Subject: Disapproval of the Groundwater Flow Model Report

Attachment A: Joint Agency Deficiencies on the Groundwater Flow Model Report, Red Hill Bulk Fuel Storage Facility, dated March 25, 2020

HAWAII DEPARTMENT OF HEALTH TECHNICAL REVIEW

Figure 1. A comparison of the observed and modeled water levels across the model domain for Stress Period 1 (a) and Stress Period 3 (b) as simulated by Model #54.

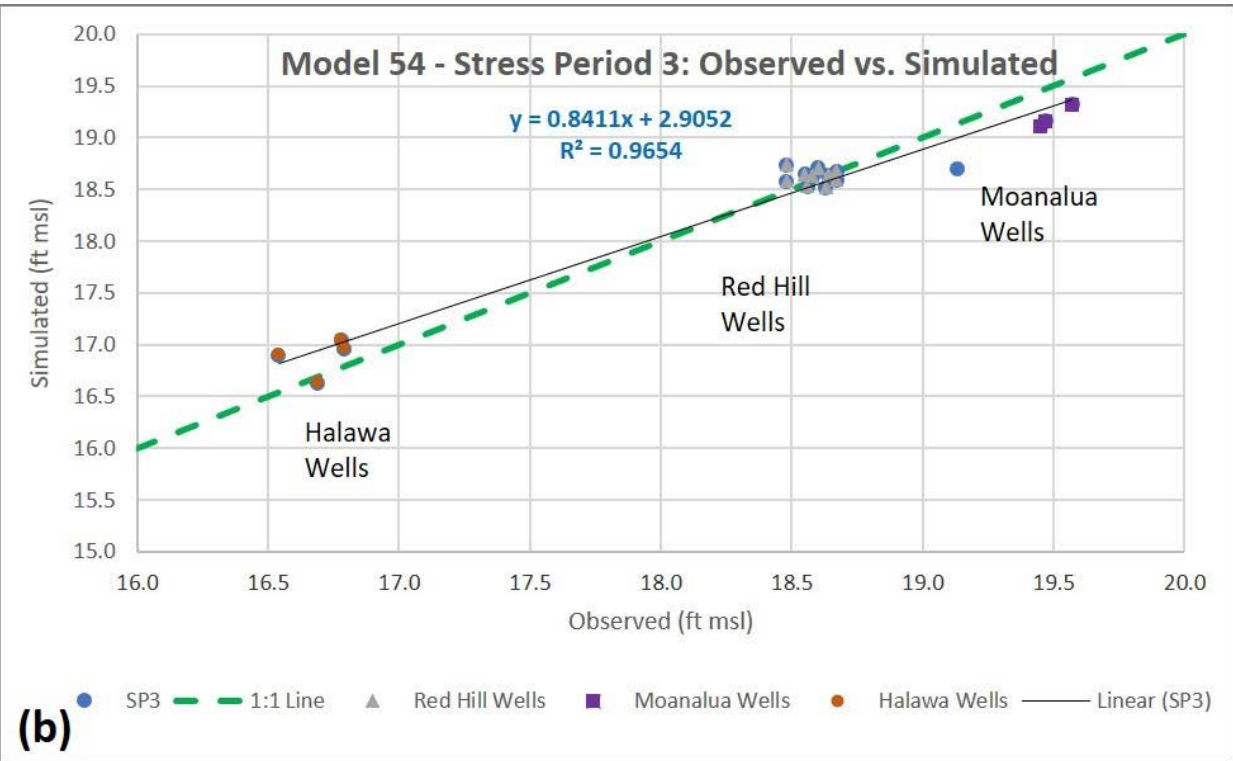
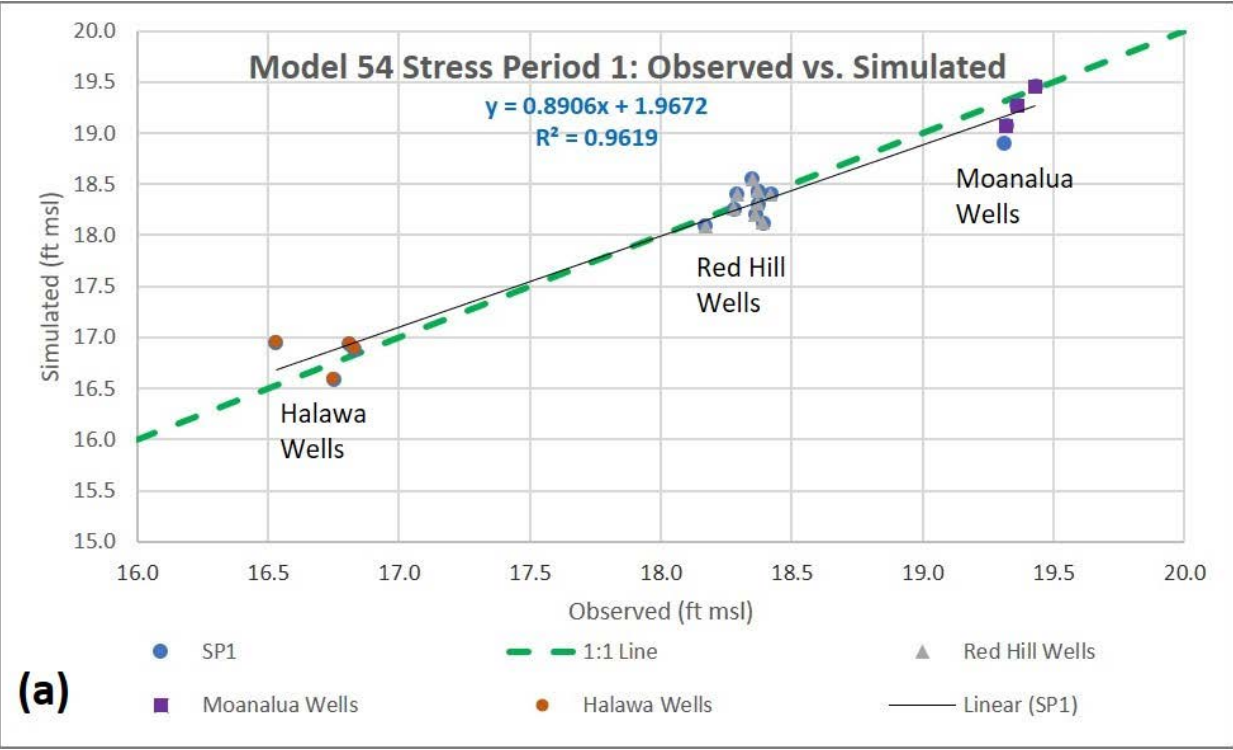
Figure 1a and 1b show the observed groundwater elevations compared to those simulated by Model 54. The observed groundwater elevation values for Stress Period 1 (SP1, Red Hill Shaft pumping at an average rate) and Stress Period 3 (SP3, Red Hill Shaft not pumping) were taken from Figures 3.1-2 and 3.1-3 of the GWFM report respectively. The simulated groundwater elevation values were computed by subtracting the Model #54 residual mean error in Figure 5.4-5 from the target hydraulic heads in Figures 3.1-2 (SP1) and 3.1-3 (SP3). Figures 1a and 1b reflect the Navy's priority of calibrating the model to match the measured groundwater elevations across the model domain from the Moanalua Ridge to Aiea. This agreement between modeled and measured groundwater elevations is indicated by the high coefficient of correlation with data points falling along the 1:1 observed versus simulated line shown by the green dashes. However, as described below, the model performs poorly when simulating the response of the Facility monitoring wells to changes in pumping stresses at the Red Hill Shaft.

Figure 2. Groundwater elevation measured, modeled, and best fit lines for the wells along the centerline of the Red Hill Ridge (a) and along northwest side of the Red Hill Ridge (b)

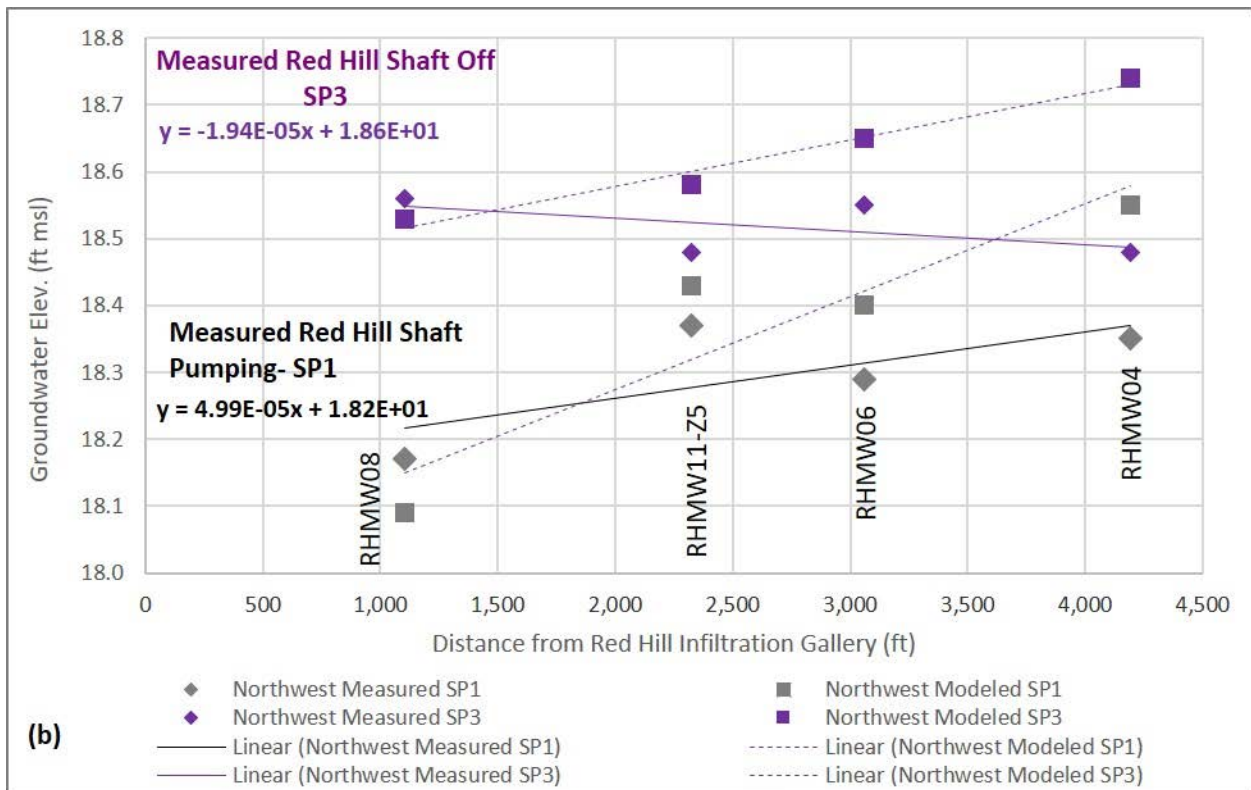
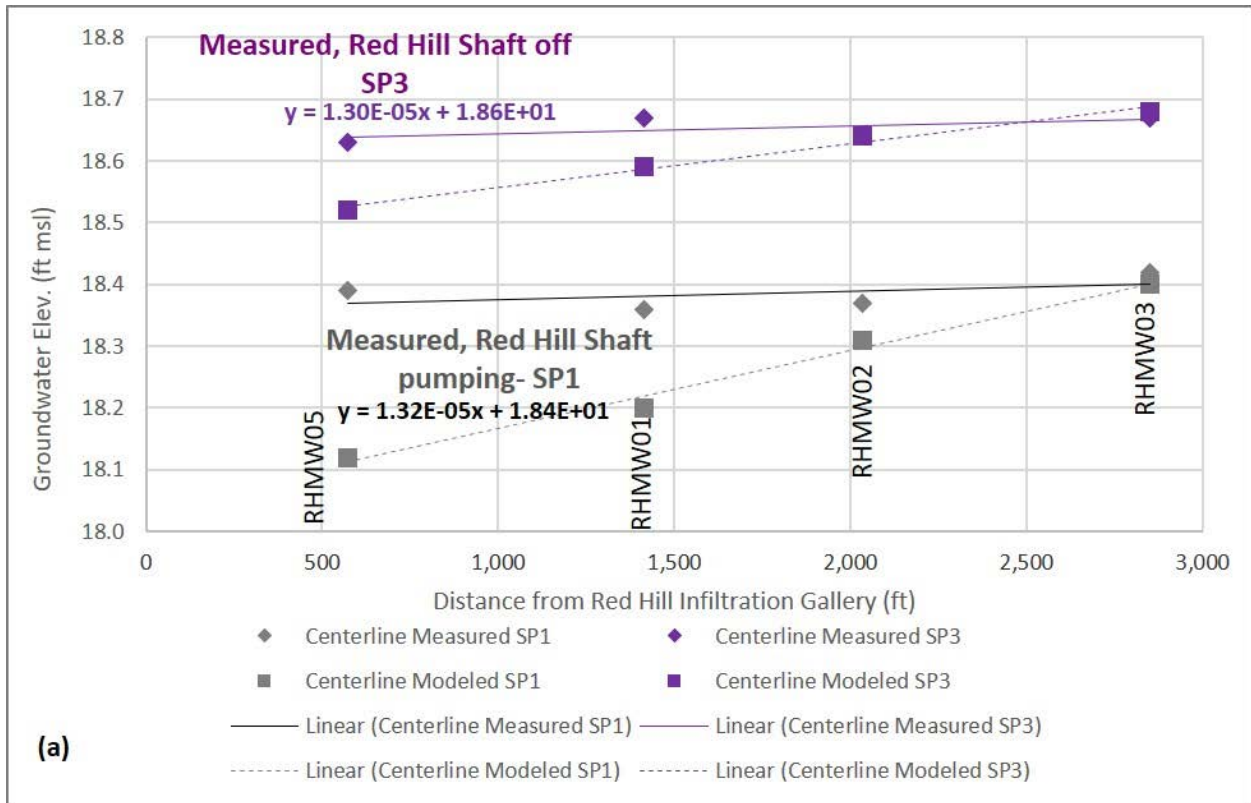
The key observation for Figure 2(a) is that the measured response to changes in pumping stresses in the groundwater elevations is markedly different from that modeled. The slope of the best fit line for the **measured** groundwater elevations is **the same** for the **Red Hill Shaft off (SP3)** and the **Red Hill Shaft pumping (SP1)** showing no increase in the hydraulic gradient between a non-pumping and pumping condition. By contrast, the best fit lines for the modeled gradients for **both SP1 and SP3 show: a much greater slope than that for the measured groundwater elevations;** and, **a much steeper slope** for the Red Hill Shaft pumping stress period (SP1) than for the Red Hill Shaft off (SP3). The modeled groundwater elevations show the gradient that is necessary to move groundwater down Red Hill Ridge along the flow trajectory indicated by the particle tracks. Because there is **no change in the slope** of the best fit line for the **measured water levels between the Red Hill Shaft pumping and non-pumping conditions**, we conclude, contrary to the modeling results, that **the groundwater beneath the USTs and along the path to the Red Hill Shaft is not significantly mobilized by normal pumping of the Shaft.** We

Figure 2(b) performs the same evaluation for the wells along the northwest boundary of the Facility (RHMW04, RHMW06, RHMW11, and RHMW08). **There is a definitive response in the measured gradients observed** in the northwest wells between Red Hill Shaft pumping (SP1) and not pumping (SP3). **The critical observation for these wells is the apparent reversal in the observed gradient from downslope when the Red Hill Shaft is pumping to upslope when the Red Hill Shaft is off.** By contrast, the **modeled groundwater elevations show the gradient going downslope under both pumping and non-pumping conditions**, and show no reversal, but only a steepening of that gradient, when the Red Hill Shaft is on.

The divergence in the measured and modeled responses to changes in pumping conditions at the Red Hill Shaft cast serious doubt on the ability of the model to predict a capture zone for the Red Hill Shaft. Hence, these models, as presented, can't provide a reliable groundwater flow field for the contaminant fate and transport models. **These discrepancies indicate the modeled groundwater flow trajectories beneath the USTs are neither valid nor sufficiently reliable to guide response and remediation strategies or for use in assessing risk associated with future releases.**

Figure 3. (a) regional chloride concentration in Moanalua/Halawa Area Wells and a hypothetical distribution of chloride in the groundwater beneath the Facility based on regional chloride concentrations. (b) Particle tracks from Model 52, and the Navy's proposed chloride source areas are added

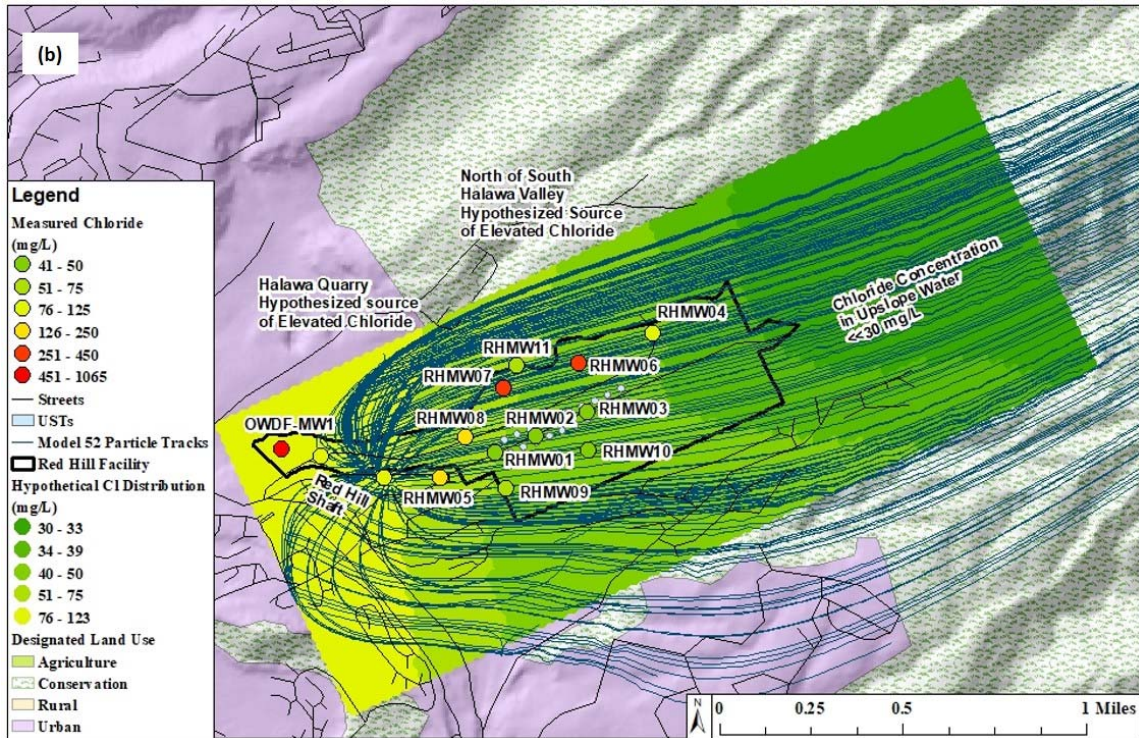
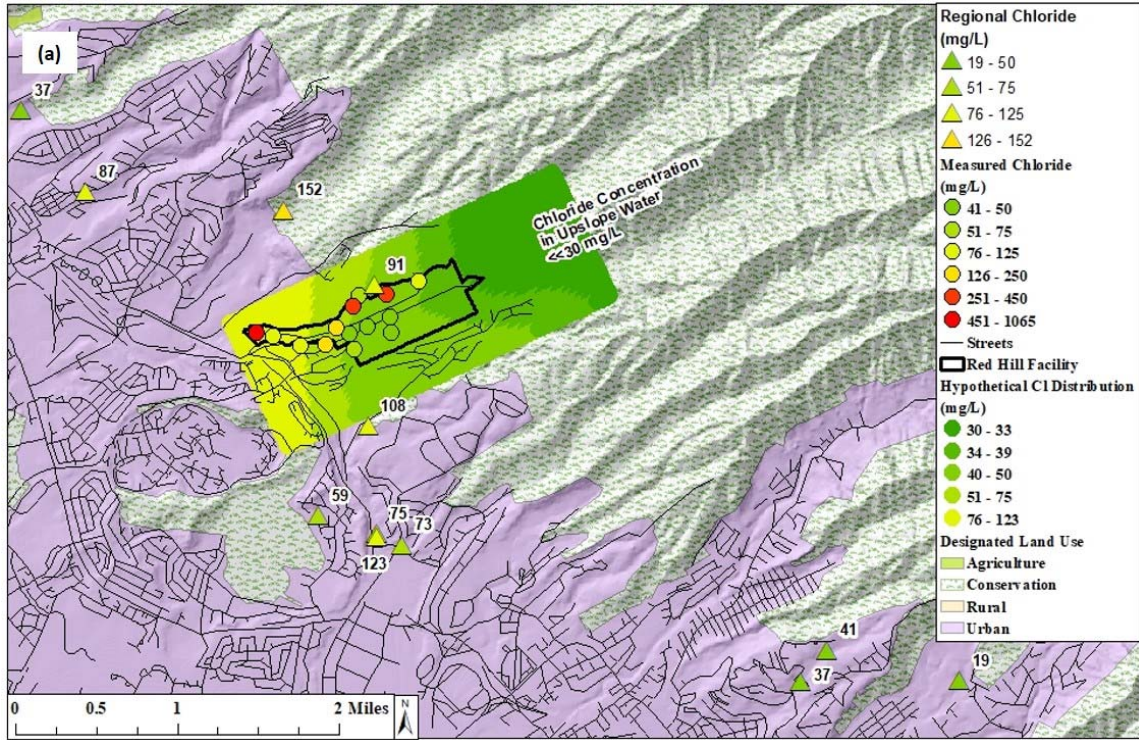
Figure 3(b) focuses on the Facility and shows the particle tracks simulated by Model 52. As with nearly all the GWFM simulations, the flow trajectory is only slightly oblique from going down the axis of the Red Hill Ridge. Most of the path lines don't pass beneath any developed area or known source of chloride prior to reaching the Facility boundaries. This suggests that chloride concentration within the Facility should be closer to that of the recharge areas than to the downslope production wells. Compared to the hypothetical chloride distribution, wells RHMW04, RHMW06, RHMW07, RHMW08, RHMW05, and OWDF-MW1 stand out as having chloride concentrations significantly greater than those implied by the GWFM. The chloride concentrations in wells RHMW06, RHMW07, and OWDF-MW1 are

The key point of this analysis is to show that the modeled groundwater flow field and the measured groundwater chloride within the facility wells can't be reconciled unless a source of chloride can be identified that falls within the modeled zone of contribution to the Red Hill Shaft. If the footprint of the particle tracks shown in Figure 3(b) indicates the zone of contribution to the Red Hill Shaft, there must be a source of significantly elevated chlorides within that zone of contribution. Figure 4(b) also shows the location of elevated chloride hypothesized by the Navy. Both the Halawa Quarry and the area "north of South Halawa Valley" (CSM Page 6-31, Line 44 and 6-32, Line 1) are well outside of the simulated zone of contribution for flow down the Red Hill Ridge.

Figure 5. Modeled Groundwater Elevations Compared to Actual Synoptic Data Verification Model Variances to Measured Red Hill Area Well

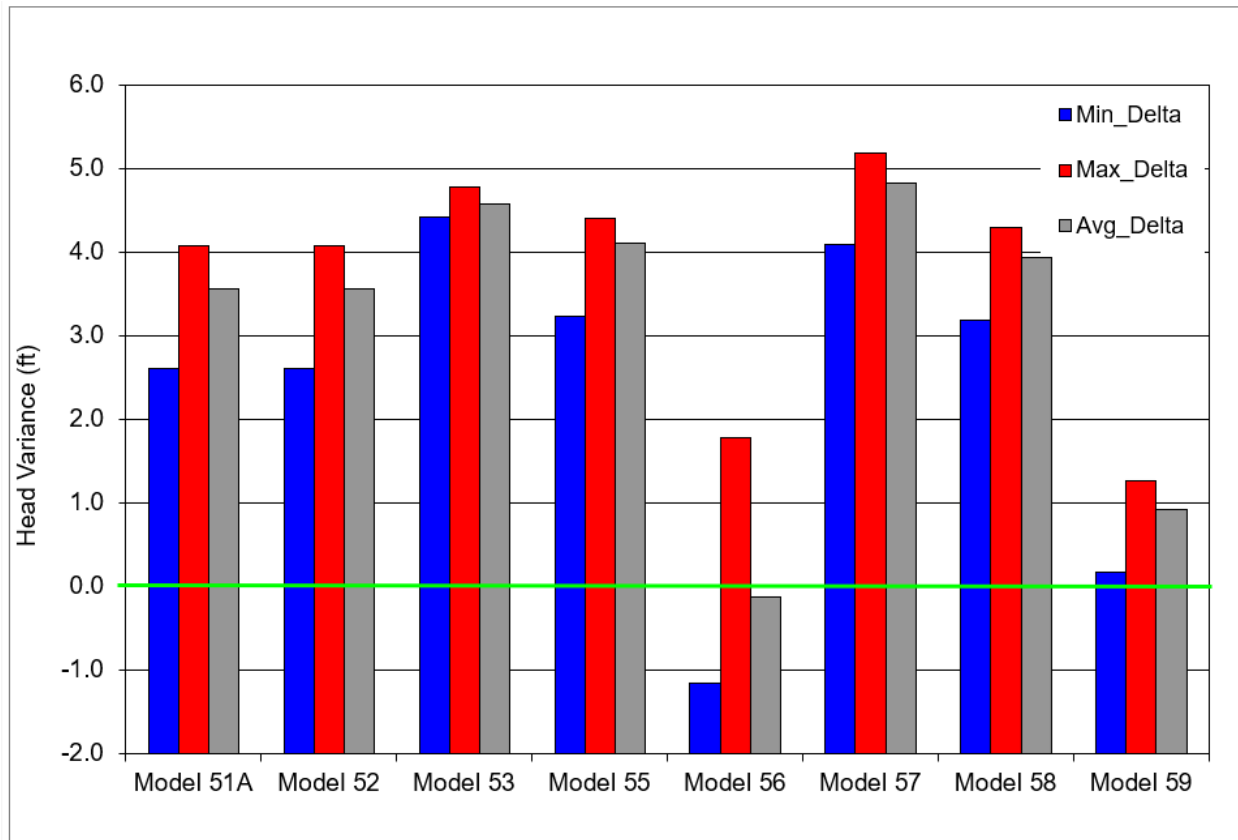
However, in the draft numerical models provided, the DOH SME team is unable to duplicate the results that are presented in the Navy GWFM report. This was discussed in one or more working meetings. It appears to the DOH reviewers that the GWFM drawdown results were superimposed on measured groundwater elevation data, as opposed to the modeled groundwater elevations. The DOH is unable to replicate the model verification results presented by the Navy in the GWFM report.

In our execution of the Navy's draft numerical groundwater flow models, there is substantial variance between the measured groundwater elevations versus those modeled. Groundwater elevations are much more important than drawdown/recovery because they reflect aspects of the total water budget and system behavior. Figure 5 shows the head variance between various verification model runs and the actual heads from the synoptic water level data. Except for Model 56 the simulated hydraulic head is significantly higher than the measured head hydraulic head. Transient drawdown/recovery is relatively easy to match by modeling, groundwater elevations are typically more difficult to match, but are more important. Unless the draft models were updated relative to those the agencies received, the verification simulations are unacceptable. Rather than showing strong concurrence with measured data, they are highly in error. If these observations are the result of model changes not available to the DOH, then we request those model updates so that we can again compare the verification simulation against measured groundwater elevations. If the models have not been updated in any substantial manner, then the verification runs directly demonstrate that full suite of GWFMs are demonstrably flawed.

Figure C-2: Gross Schematic of Bedrock Fabric and Orientation of any Preferential Pathways

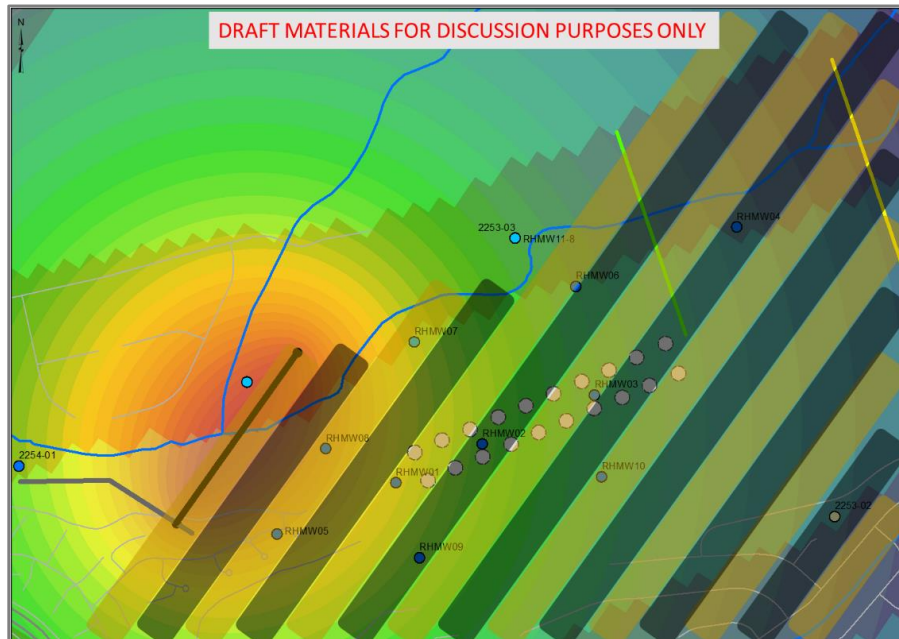
Example 2: predicting hydraulic containment (capture zones) particularly at smaller or transient rates. The presence of an aquifer fabric like that depicted in **Figure C-2** presents difficulties in the deterministic interpretation of hydraulic containment (capture). In such a system, groundwater flow compartmentalization can be as significant laterally (such as between adjacent clinker zones) as it is vertically; and this can mean that the water recovered by pumped wells is more vertically derived than would be anticipated using a homogeneous-anisotropic assumption and approach. This possibility is supported by the easternmost extents of the boring log of the Red Hill tunnel (**Figure C-4**). Although the effects of compartmentalization may appear to homogenize at very large pumping rates, at lower pumping rates the effects of compartmentalization can be pronounced and can lead to misinterpretation of the source of water to pumped wells.

Recommendation(s): evaluate and implement alternate methods to represent subsurface heterogeneity. The subsurface in the vicinity of RHBSF is neither homogeneous such as represented in several of the models, nor does it demonstrate radially symmetric heterogeneity such as generally produced using the pilot point method. Alternative, structure-imitating, methods for representing subsurface heterogeneity in basalt settings should be considered that, while not deterministic, provide more realistic parameter fields and can be calibrate. Examples include multiple-indicator and multi-point (geo)-statistical methods that can be conditioned on local stratigraphic data such as that recorded in the barrel logs; and methods derived from sequence-stratigraphy to stack and accumulate lava sequences.

Figure C-3: Results of Structure-Imitating Stochastic Lava Simulations

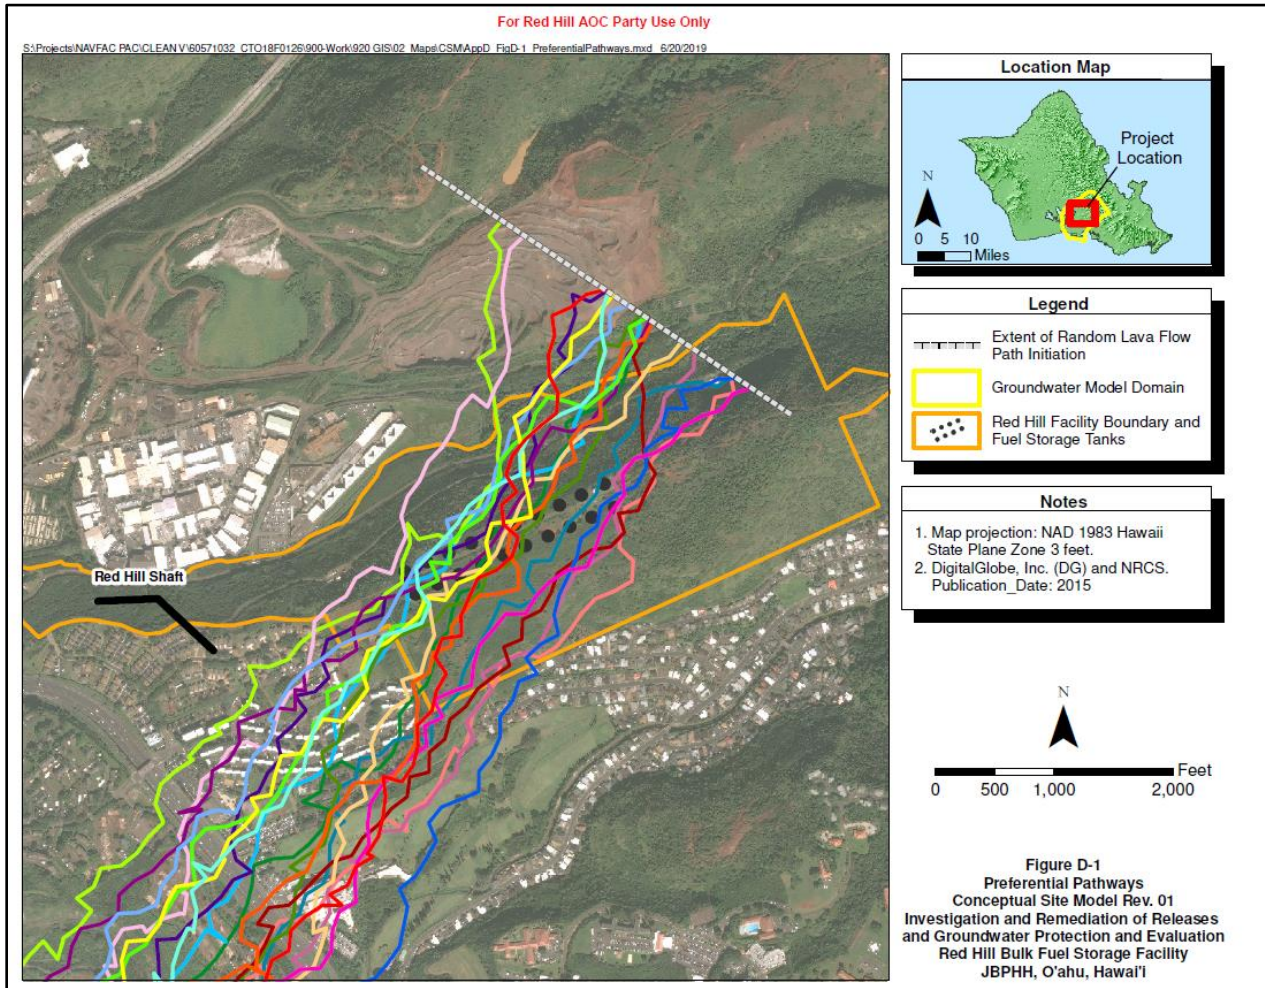
Figure D-1 from the CSM (included here as **Figure C-3**) illustrates 20 of these 10,000 Monte Carlo paths. The pattern of stochastic pathways is generally consistent with expectations based upon SME knowledge and with the concept depicted in **Figure C-2**. However, it appears from this analysis that preferential transport pathways may not pass through substantial portions of the groundwater monitoring network nor be detectable at RHS (at least, when it is not pumping). As previously noted by the EPA/DOH in comments provided on the CSM (April 22, 2019):
